Work Order ID 65008

Item Name: 5-Man Fwd Facing Shoulder Harness, 3 point

DART SERVICE INSTRUCTION

TO AMEND INSTALLATION INSTRUCTIONS IIN-D412-702 REV. D & E

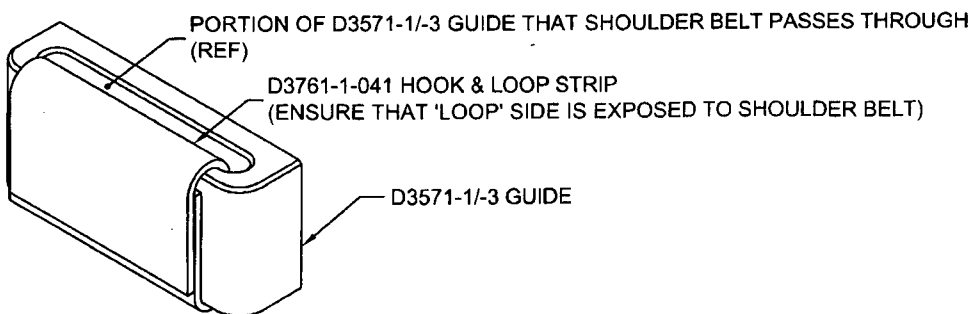
DSI9408-011/-013/-015/-017 Hook and Loop Strip Kits are available to upgrade existing D412-702-041A/-043A/-045A/-049A/-051A/-051B/-052A/-052B 3-Point Shoulder Harness Kits at CHG 001 and D412-702-041B/-043B/-045B/-049B 3-Point Shoulder Harness Kits at CHG 002. The DSI9408-011/-013/-015/-017 kits are included in D412-702-041A/-043A/-045A/-049A/-051A/-051B/-052A/-052B kits at CHG 002 and D412-702-041B/-043B/-045B/-049B kits at CHG 003.

The DSI9408 kits provide D3761-1-041 hook and loop strips that help prevent passengers from inadvertently pulling the shoulder belts out of the D3571-1/-3 guides. Installation of the D3761-1-041 hook and loops strips is optional.

The D3761-1-041 hook and loop strip is installed by wrapping the strip tightly around the front face of the D3571-1/-3 guide so that the "loop" side of the strip is exposed to the shoulder belt as shown in the figure below. The kits are as follows:
